Browns Ferry Nuclear Plant, Units 1, 2, and 3
Renewed Facility Operating License Nos. DPR-33, DPR-52, and DPR-68
NRC Docket Nos. 50-259, 50-260, and 50-296

Subject: **Proposed Technical Specifications (TS) Change TS-505 - Request for License Amendments - Extended Power Uprate (EPU) - Supplement 25, Responses to Requests for Additional Information**

**ANP-3495P, Response to RAI for Browns Ferry Nuclear Plant EPU Submittal –
SFSP Criticality Safety Analysis, Round 2**

Figure 1: Potential Missing Boron Plate Near Edge of Rack (illustration only)

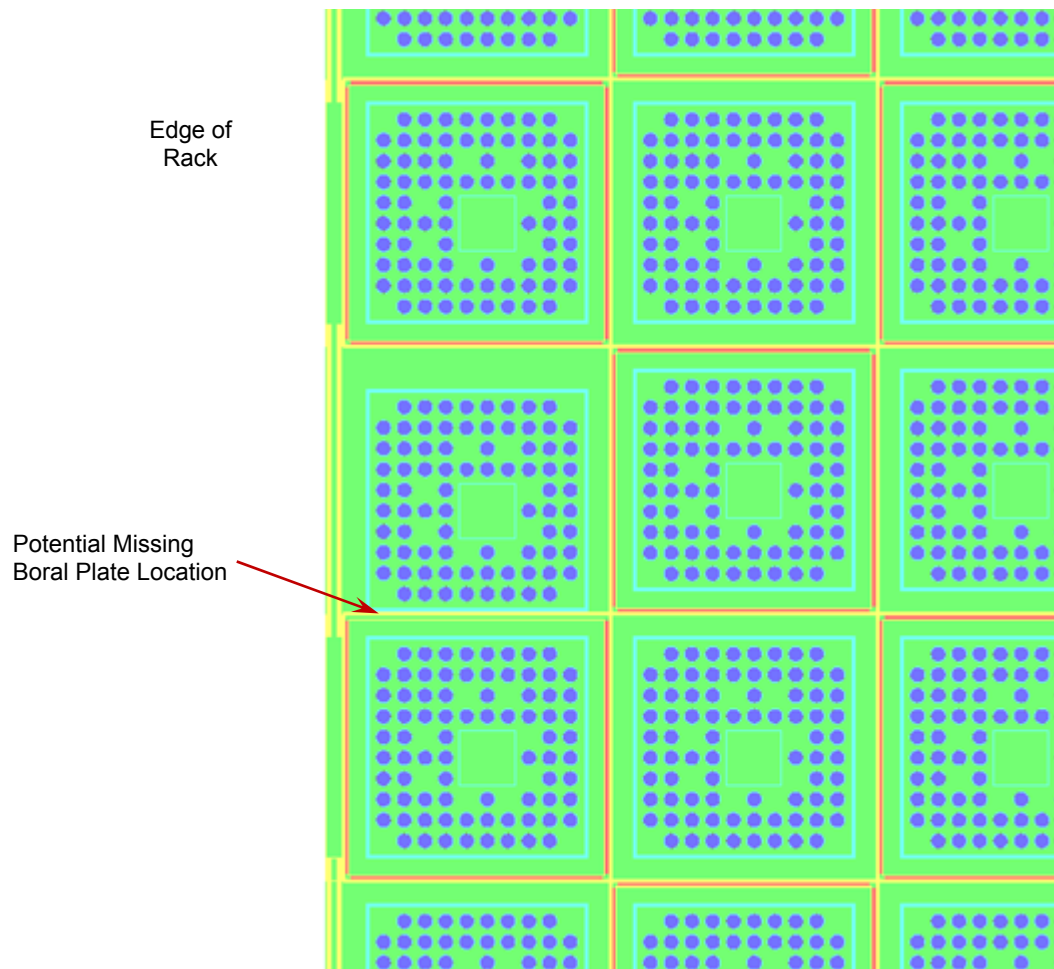
- a. A discussion of the controls in place at the plant to ensure that the nominal rack module spacing is maintained for normal operating conditions, or*
- b. If no such controls exist, a discussion of the reactivity impact of potential reductions in rack module spacing on the normal and accident conditions. For example, an accident configuration postulating a single missing Boral plate assumes that the missing plate is located on the interior of a SFP rack module. Other possible configurations involving missing Boral plates do not appear to have been analyzed. For example, a missing Boral plate might be located at the periphery of a SFP rack module, in such a location that results in three face adjacent fuel assemblies without Boral plates between them.*

Additional calculations have been performed to specifically address the potential impact of a missing Boral plate on or near the edge of the 13x13 rack module. Two locations were chosen for a missing plate analysis; 1) a missing outside plate (i.e. between the racks), and 2) a missing adjacent plate (i.e. an inner plate in an edge cell). This second location is the same as that identified in the question (i.e. three face adjacent fuel assemblies). This second condition would be the expected limiting condition because it has the potential for higher reactivity due to closer spacing of the fuel assemblies with no neutron absorber between the assemblies. In contrast, the missing edge plate scenario still has absorber between the assemblies as part of the Boral tube in the adjacent rack.

Table 2 also shows that the limiting missing Boral plate result occurs for this same spacing condition in which the base plates of the racks are in contact. The missing plate analyses in Table 1 assume the assemblies are centered within their individual cells. The limiting no rack spacing scenario was further evaluated in an attempt to optimize the reactivity change with alternate assembly placements within the cells adjacent to the missing plate. Specifically, a series of three additional cases were examined as summarized in Table 2. These analyses indicate a maximum impact of less than 2 mk (0.0015 Δk) for a missing Boral plate near the edge of the rack. The configuration for this limiting condition is illustrated in Figure 1. The reactivity impact for this configuration is significantly below the 6 mk (0.006 Δk) determined for an internal missing Boral plate and included as the limiting accident condition in the $k_{95/95}$ result through the Δk_{sys} term (Section 7.8 of Reference 4).

Description	k	Δk
Base Case – no missing Boral plate	0.8959	--
Missing adjacent plate – centered	0.8968	0.0009
Missing adjacent plate - assembly in non-Boral tube moved to missing plate	0.8974	0.0015
Missing adjacent plate - assembly in both non-Boral and Boral locations moved to missing plate	0.8956	-0.0003
Missing adjacent plate - assembly in non-Boral tube moved to missing plate and assembly in Boral tube moved ½ the distance to missing plate	0.8973	0.0014

Figure 2: Gadolinia Pin Locations (based on the Bottom Reference Bounding Lattice)

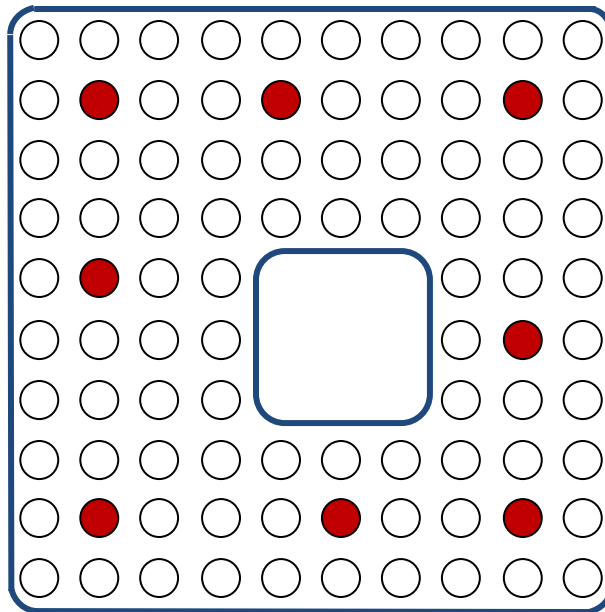
ANP-3160 states that the gadolinia manufacturing uncertainty is evaluated with a combination of KENO V.a and CASMO-4. Since the final criticality analysis utilizes a REBOL lattice with no gadolinia, it is not clear how the gadolinia manufacturing uncertainty was determined using KENO V.a. CASMO-4 appears to be used primarily to compute a depletion based adder. Provide a description of the model used in KENO V.a to evaluate the gadolinia manufacturing uncertainty.

As shown in Figure 2.2 of ANP-3160(P) (Reference 4), the reference bounding assembly is comprised of lattices XMLCT-470UL-8G35 and XMLCB-470UL-8G3919. The gadolinia tolerance was calculated for 3.5% and 3.919% gadolinia. The larger tolerance value was then rounded up and subtracted from the associated gadolinia concentration, 3.919%. The 2x2 storage cell KENO model was then modified to include 8 gadolinia rods in the locations shown in Figure 2 (red representing the gadolinia rods). Calculations were performed with all gadolinia rods at 3.919% and then again using the lower concentration allowed by the tolerance. As indicated in Table 7.3 of ANP-3160(P), the beginning of life change in k-effective is very small. (The significant effect of the gadolinia concentration tolerance will occur at peak reactivity. This was represented with the CASMO-4 based depletion adder).

The 2x2 storage cell KENO model with 8 gadolinia rods (described above) was modified to represent the pellet density of the gadolinia rods at the minimum tolerance level. This condition increased the beginning of life k_{∞} by 0.0012 Δk . CASMO-4 cases were also created to investigate the effect of the gadolinia pellet density tolerance at peak reactivity. Based on these results a small depletion based adder was also included.

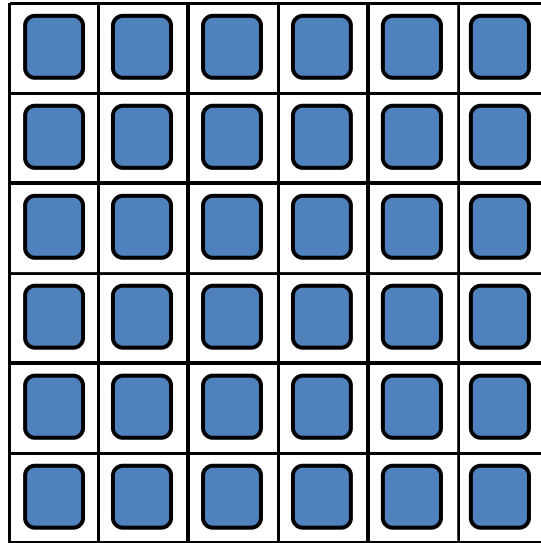
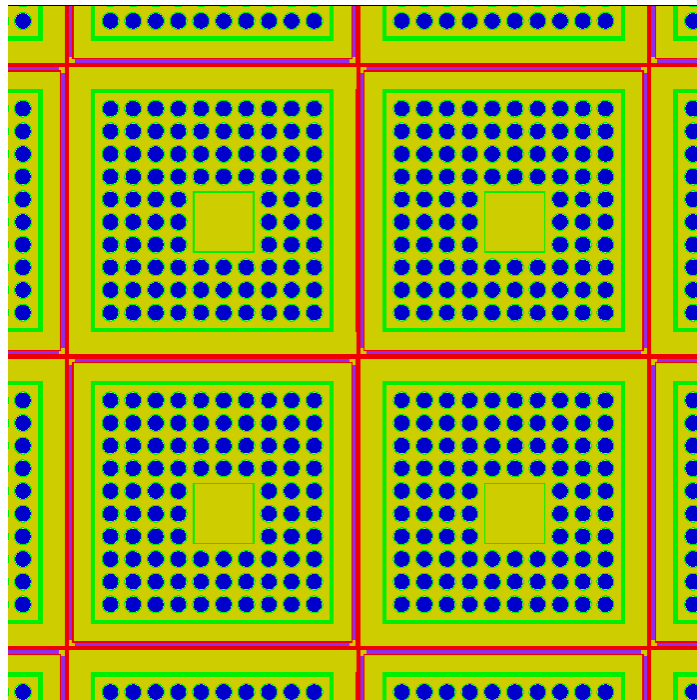
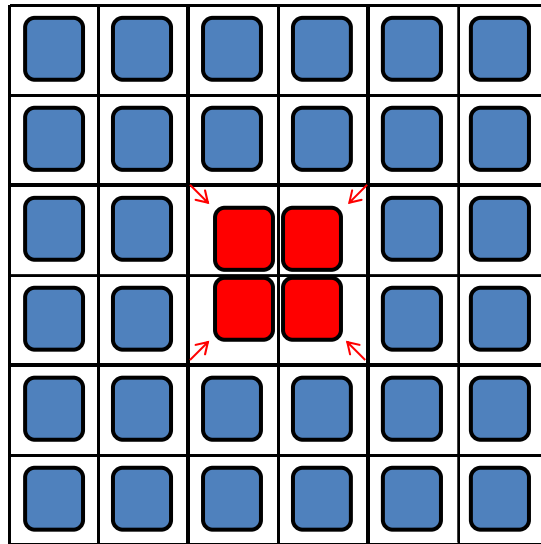
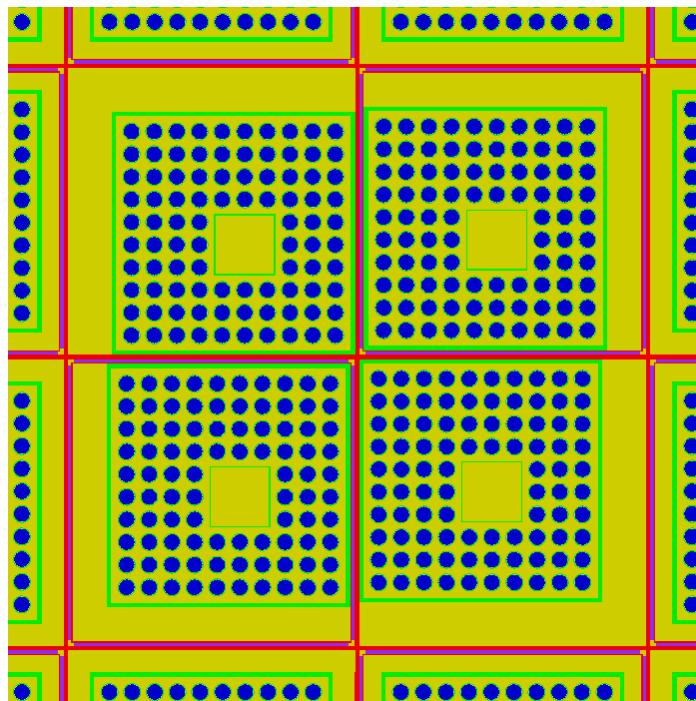
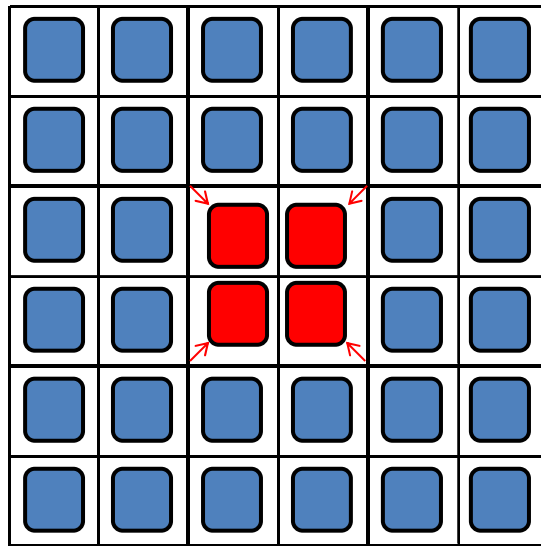
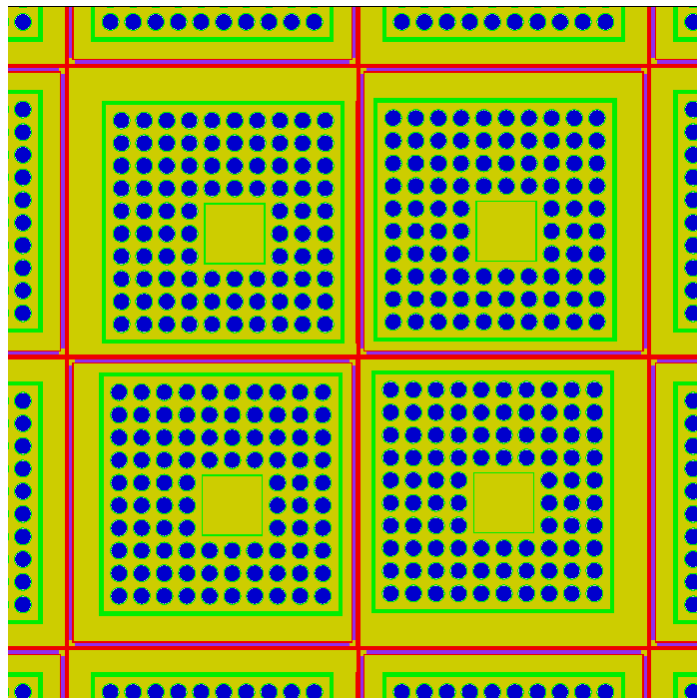
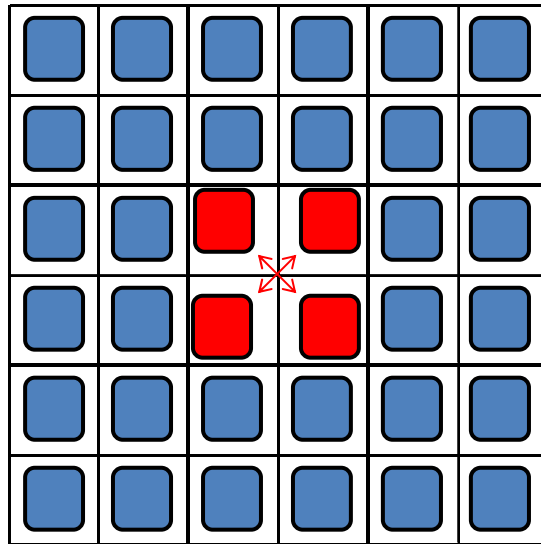
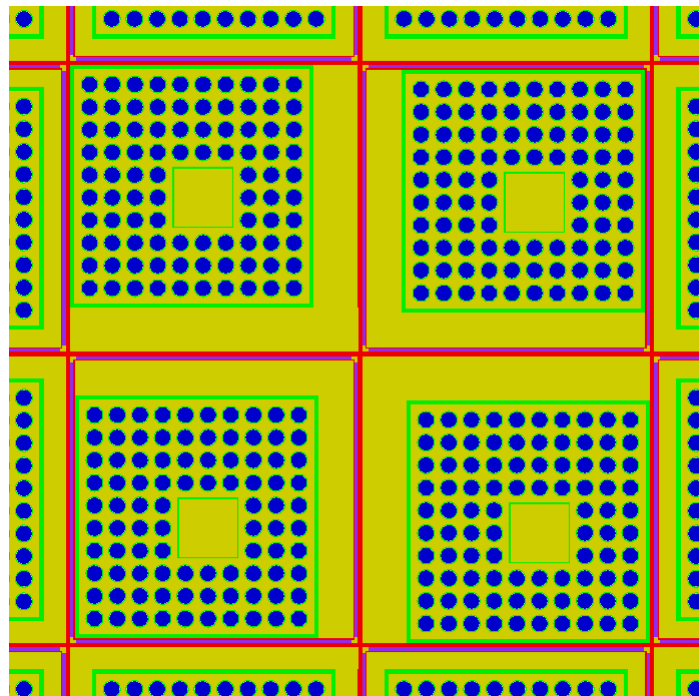
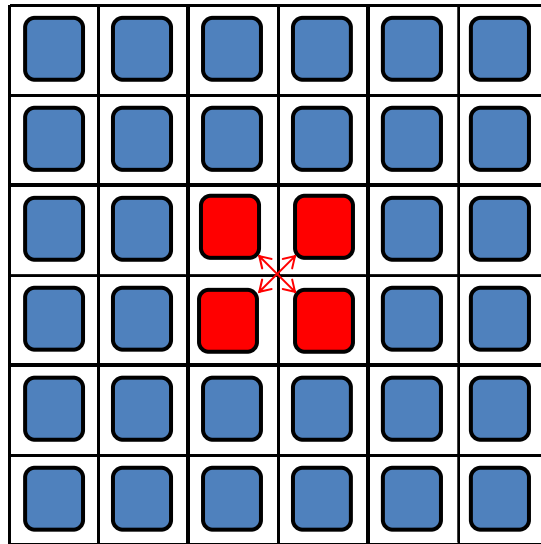
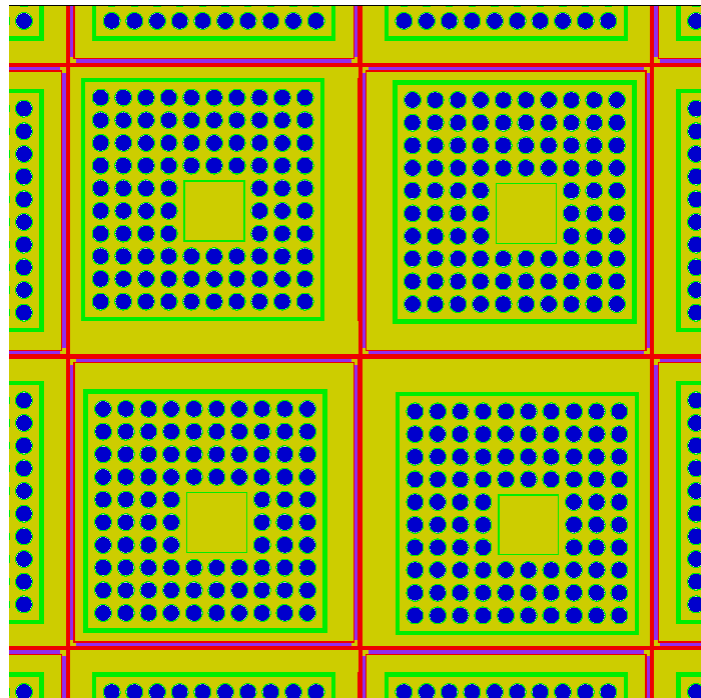
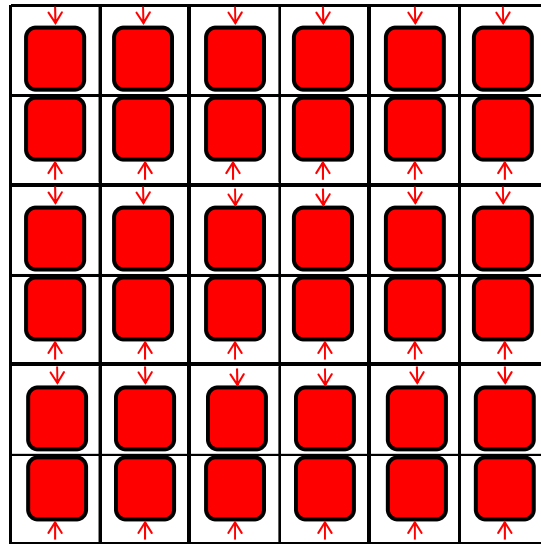
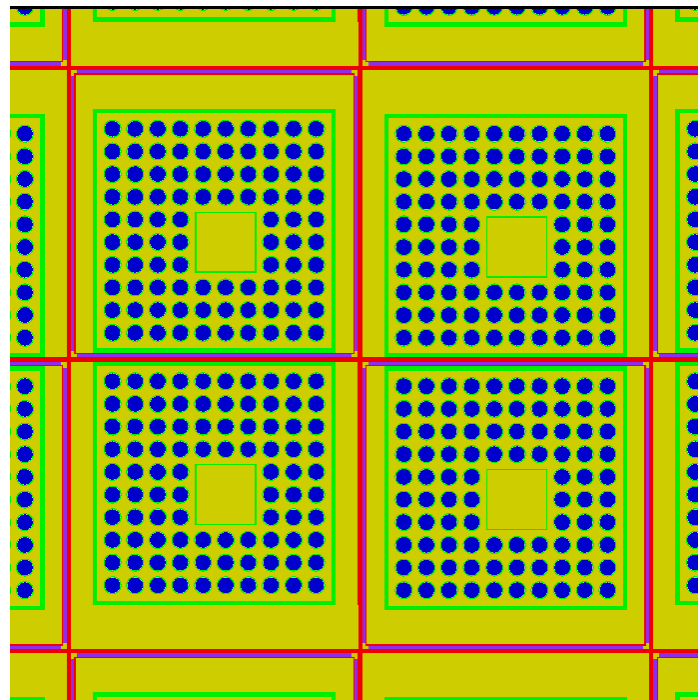
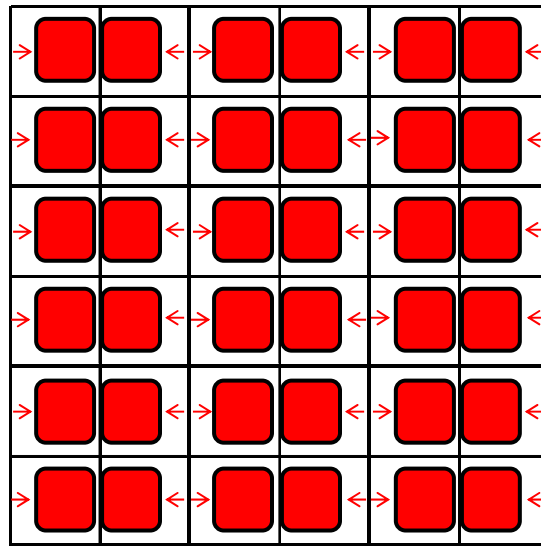
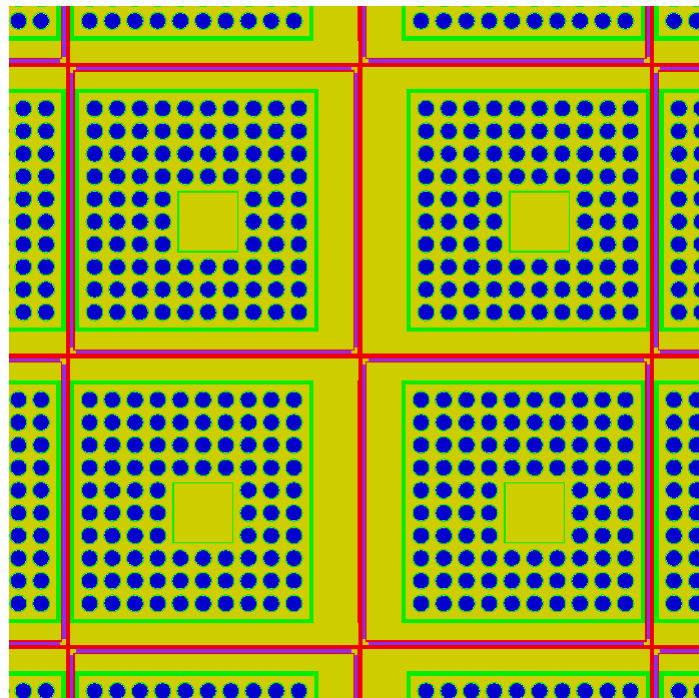
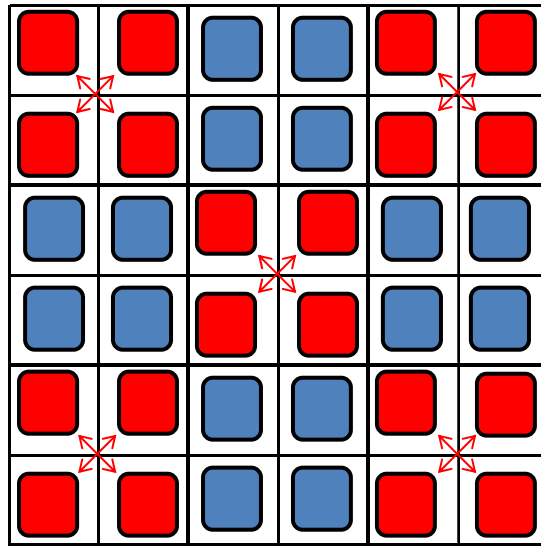
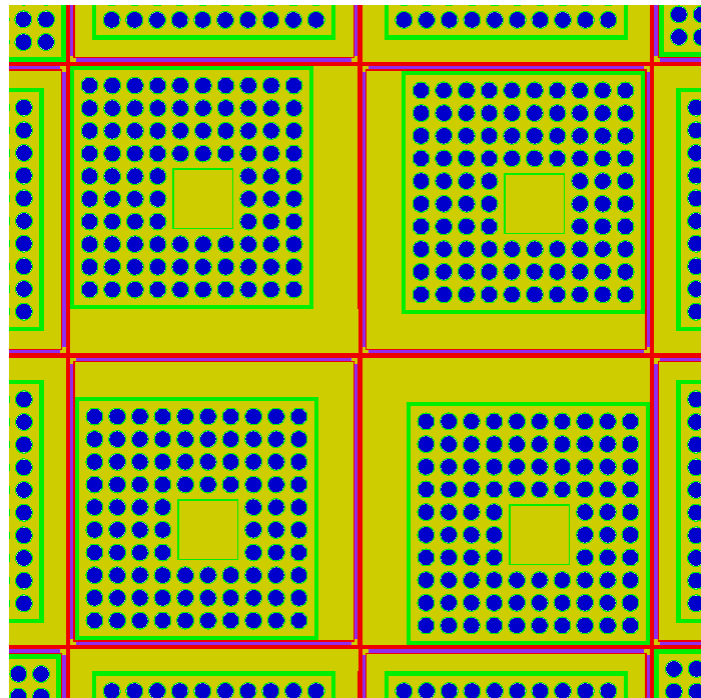
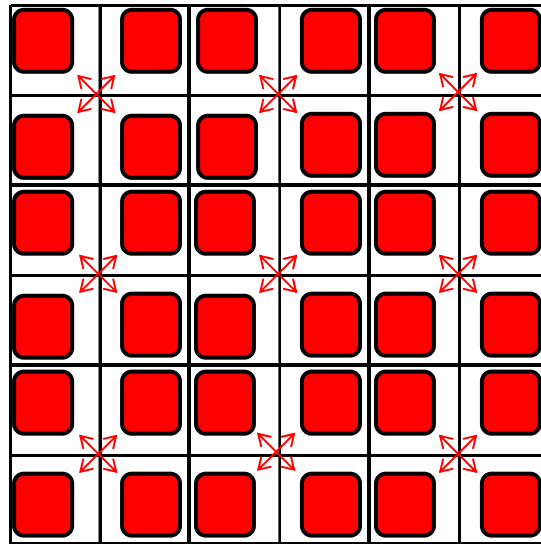
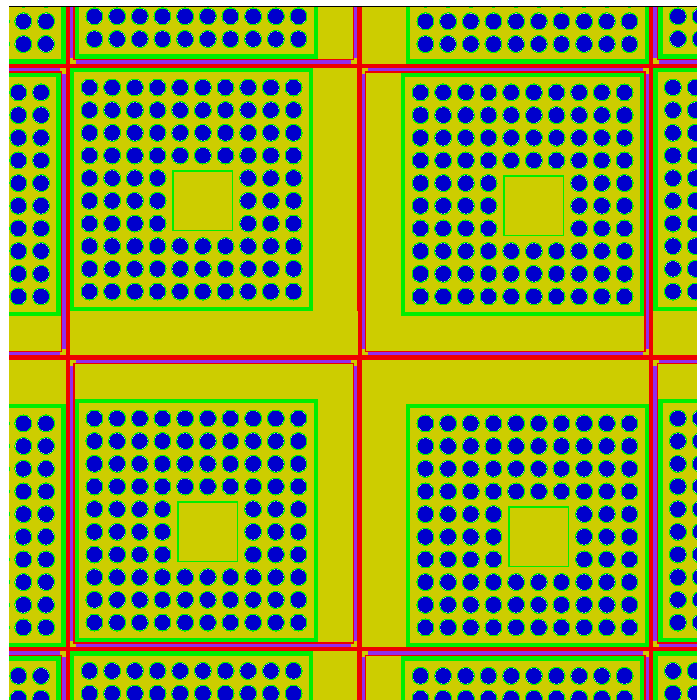
ANP-3160 discusses a series of calculations in which the radial location of the fuel lattice within the SFP cell was varied to account for fuel assembly lean. Provide additional detail on what configurations were analyzed.

A 6x6 array of fuel assemblies (with periodic axial and radial boundary conditions) was selected to evaluate assembly lean. A base case and 14 other perturbation cases were created as described in the following table. Note the calculations performed model a translation of the assemblies instead of actual leaning assemblies. It is expected that this model will bound the response of a leaning assembly where only the upper section of the assembly will experience the change.

Case	Illustration	Description
Base	Figure 3	6x6 assembly array – all assemblies centered within cell. The 6x6 array can also be visualized as a 3x3 array of groups of 4 assemblies each. i.e. 9 total groups of 4 assemblies.
Diagonally Inward	Figure 4	1, 2, 3, and then 4 of the center 4 assemblies were shifted diagonally inward while the surrounding 35 to 32 assemblies remain centered.
Half Diagonally Inward	Figure 5	The 4 center assemblies were shifted inward half the diagonal distance while the surrounding 32 assemblies remained centered.
Diagonally Outward	Figure 6	1, 2, 3, and then 4 of the center 4 assemblies were shifted diagonally outward while the surrounding 35 to 32 assemblies remain centered.
Half Diagonally Outward	Figure 7	4 center assemblies were shifted outward half the diagonal distance while the surrounding 32 assemblies remained centered.
Top and Bottom	Figure 8	Each top and bottom pair of assemblies are shifted to be adjacent to each other in the y direction while maintaining their standard spacing in the x direction.

Left and right	Figure 9	Each left and right pair of assemblies are shifted to be adjacent to each other in the x direction while maintaining their standard spacing in the y direction.
5 of 9	Figure 10	5 of the 9 groups of 4 assemblies are shifted diagonally outward the others remain centered. In terms of the 3x3 (i.e. 9) groups of four assemblies the corner and center groups are shifted.
All Clustered	Figure 11	All assemblies are shifted diagonally such that 9 groups of 4 assemblies are all face adjacent.
